# Albany Waterfront Planning Framework Report

2<sup>nd</sup> Edition

# Structure Plan Report

Revised in July 2011 to include changes involving an increase in area of the hotel, short-stay and mixed-use components of the Albany Waterfront

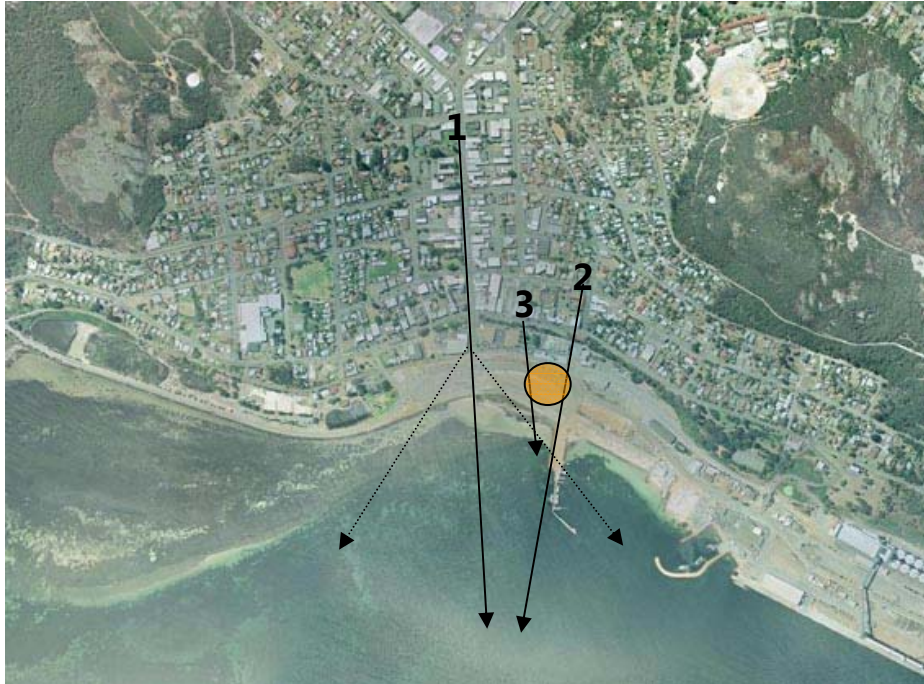
Rev: The total building area has been increased from 23,000m<sup>2</sup> to 31,000m<sup>2</sup> due to an increase in potential area of hotel, short-stay apartments and mixed use buildings

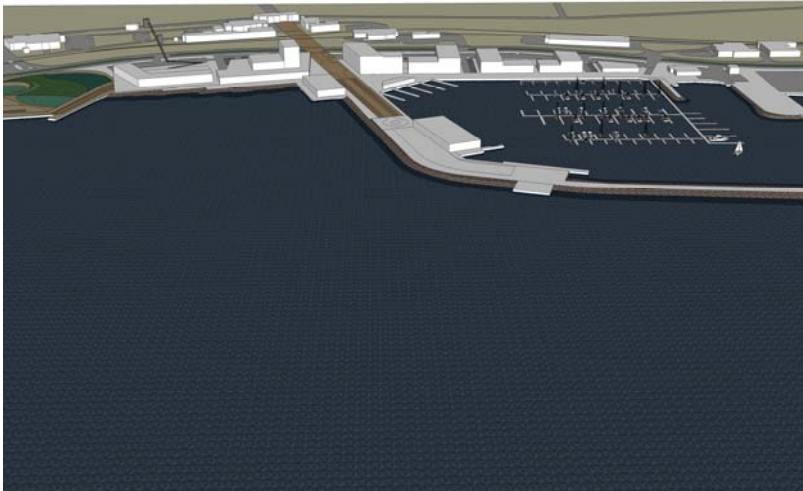
Rev: Car parking bays increased by 92 to meet the requirements of additional hotel rooms and short-stay apartments

The Structure Plan indicates area for 792 parking bays on site with additional overflow being accommodated after dark in the boat trailer car park.

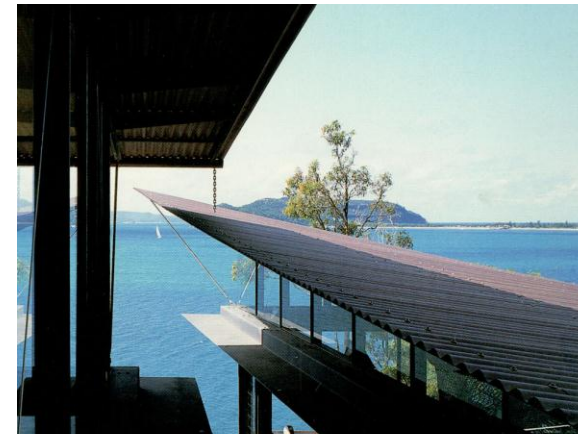
Rev: Pitched roofs with eaves restricted to single and perhaps two storey buildings.  
Low pitch roofs required for hotel and short-stay apartments.  
Green roofs are encouraged.

Rev: Low pitch, parapet roof illustration added for hotel and short-stay apartments.  
Pitched roof illustration suitable for single or two storey buildings

## Accommodation Precinct

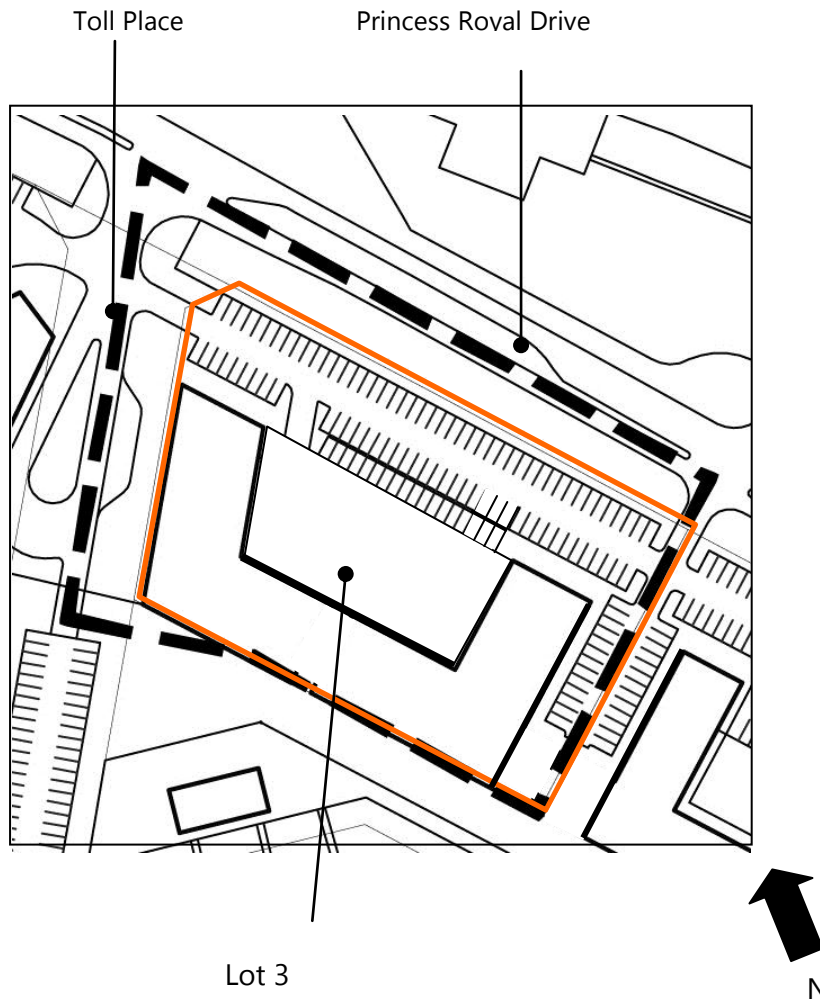
- Rev:
- Increase in plot ratio and car parking requirements.
  - Deleted reference to use of roof spaces.
  - Increase in permitted building height.
  - Plan updated to show undercover parking area on northern side.
  - Deleted required break in building edge facing promenade.
  - Deleted single storey portion on south east corner.

<b>Building height</b>	The hotel building facing Toll Place to be 5 storeys. The adjacent serviced apartment building to be 6 storeys. A building element used to signify the entry points may project beyond the roof to a maximum of 3 metres.
<b>Plot ratio</b>	Plot ratio shall be a maximum of 2.5:1 for all lots in the precinct.
<b>Parking</b>	A minimum of 222 car bays to be provided on Lot 3. This comprises approximately 83 open bays and a minimum of 139 undercover bays.
<b>Setbacks</b>	25m minimum from Princess Royal Road. 12m minimum from eastern boundary to 6 storey wall of serviced apartment building. Nil setbacks from all other boundaries.

## Commercial Precinct

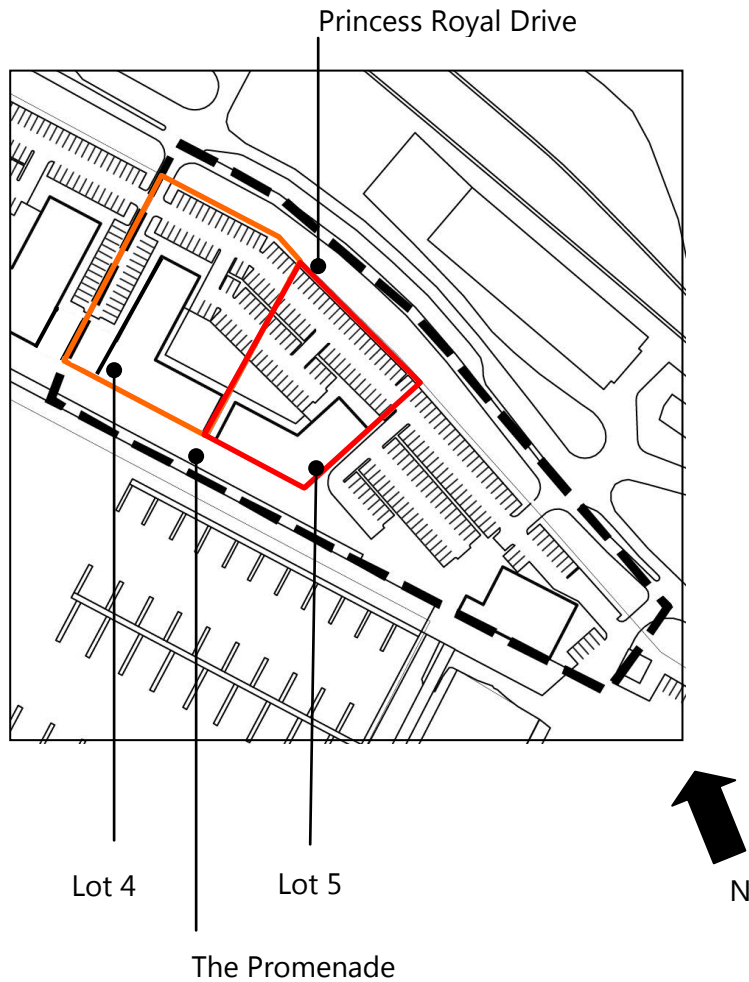
Rev: Delete reference to setback from single storey

wall on western boundary of Lot 4

<b>Building height</b>	3 storeys, provided the third floor is used exclusively for short-stay accommodation, otherwise height is limited to 2 storeys.	Rev
<b>Plot ratio</b>	Plot ratio shall be a maximum of 0.5 for all lots in the precinct.	
<b>Parking</b>	65 car bays to be provided on Lot 4. 65 car bays to be provided on Lot 5. 105 car bays to eastern side of Lot 5.	
<b>Setbacks</b>	<p>Lot 4:</p> <p>25m minimum from Princess Royal Road. 12m minimum from western boundary wall. Nil setback from the Promenade.</p> <p>Lot 5:</p> <p>25m minimum from Princess Royal Road. 2.5m minimum from western boundary. Nil setback from all other boundaries.</p>

**PROPOSED CHANGES TO STRUCTURE PLAN**

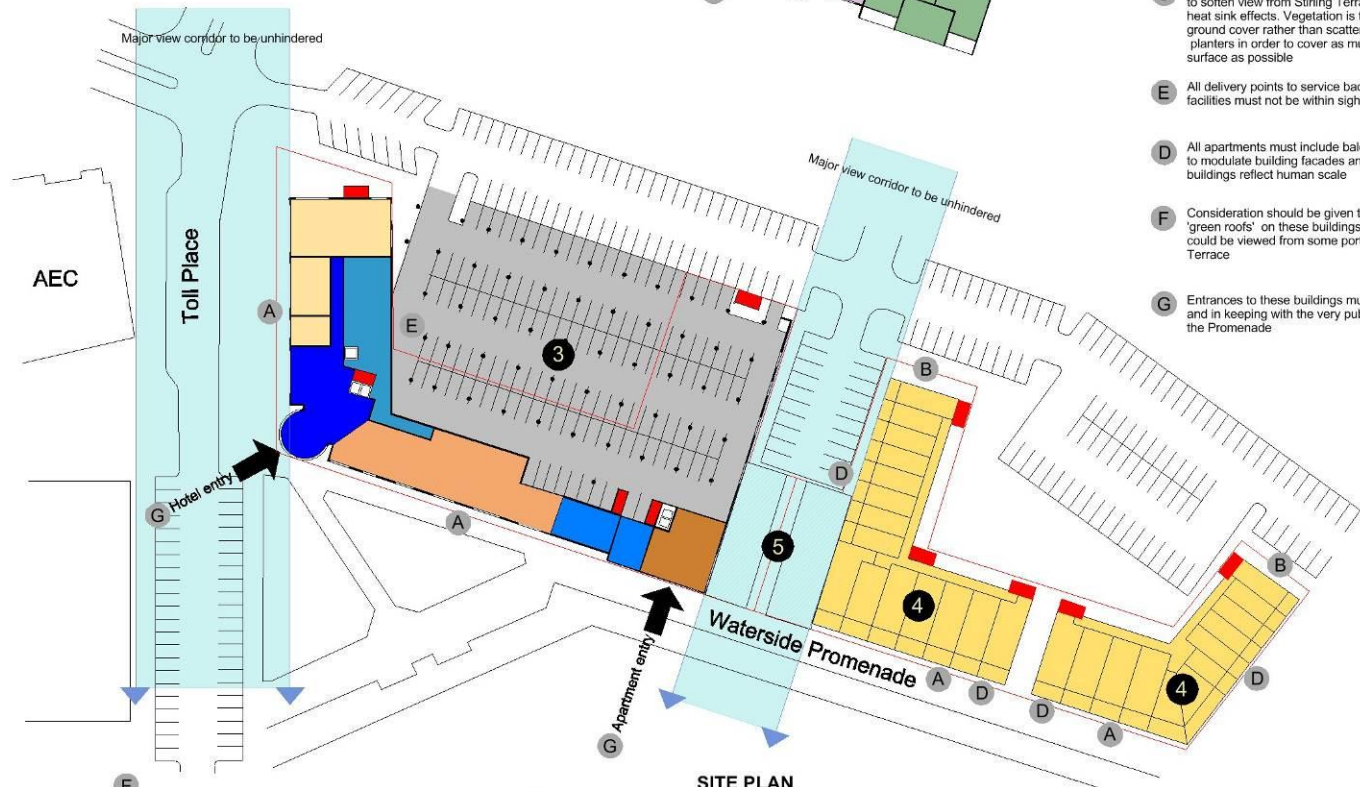
- 1** The short-stay apartments in the accommodation precinct increased from four to six floors. This increase will take the GFA from 4,600m<sup>2</sup> as noted in the Structure Plan to 6,800m<sup>2</sup>. The configuration shown here is capable of providing 80 to 90 short-stay apartments depending on mix of apartment sizes.

- 2** The hotel portion of the accommodation precinct is shown here as a continuous building adjoining the short-stay apartments. The footprint shown produces a hotel with a GFA of 10,500m<sup>2</sup> which is 3,000m<sup>2</sup> larger than the estimated hotel area noted in the Structure Plan. The hotel in this configuration is capable of providing 120 to 145 rooms depending on the mix of room sizes.

- 4** These two buildings in the commercial precinct are increased from two to three floors provided the top floor is used as short-stay accommodation. These buildings are designated mixed-use in the Structure Plan. Their approximate GFA is currently 4,500m<sup>2</sup> which will increase to 6,750m<sup>2</sup> with an additional floor. As a mixed-use development the current building would require 150 car bays. If the development became mixed-use at ground level and short-stay apartments above the car bays required would reduce to approximately 130 bays, depending on the number of apartments (54 apartments are shown as only a suggestion of potential numbers).

- Increase Short-stay Apartments from four to six floors
- Increase Commercial Mixed-use buildings from two to three floors

120 to 145 hotel rooms  
134 to 144 short-stay apartments  
A GFA increase from 16,600m<sup>2</sup> to 24,050m<sup>2</sup>

**VIEW FROM STIRLING TERRACE**

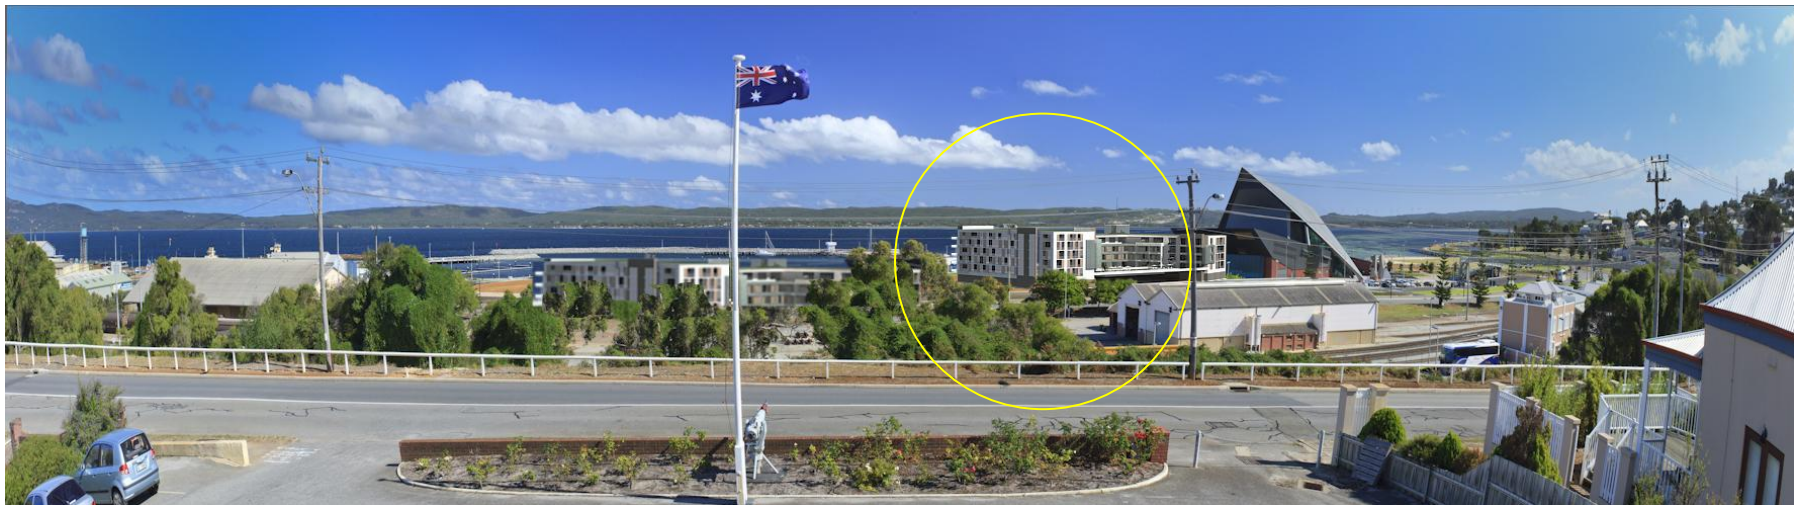
Above - Possible development scale under proposed amendments

## VIEW ALONG THE SPENCER STREET VIEW CORRIDOR

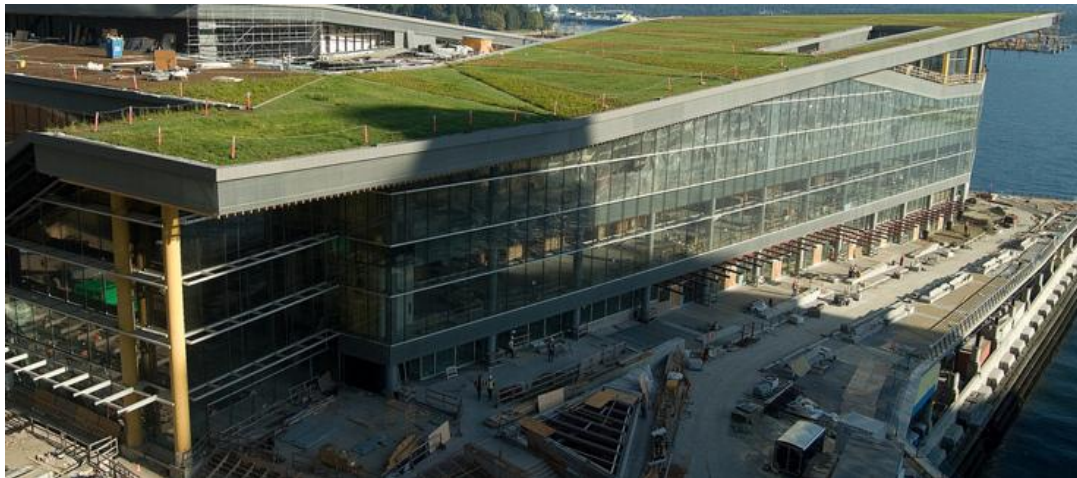
Above - Possible development scale under proposed amendments
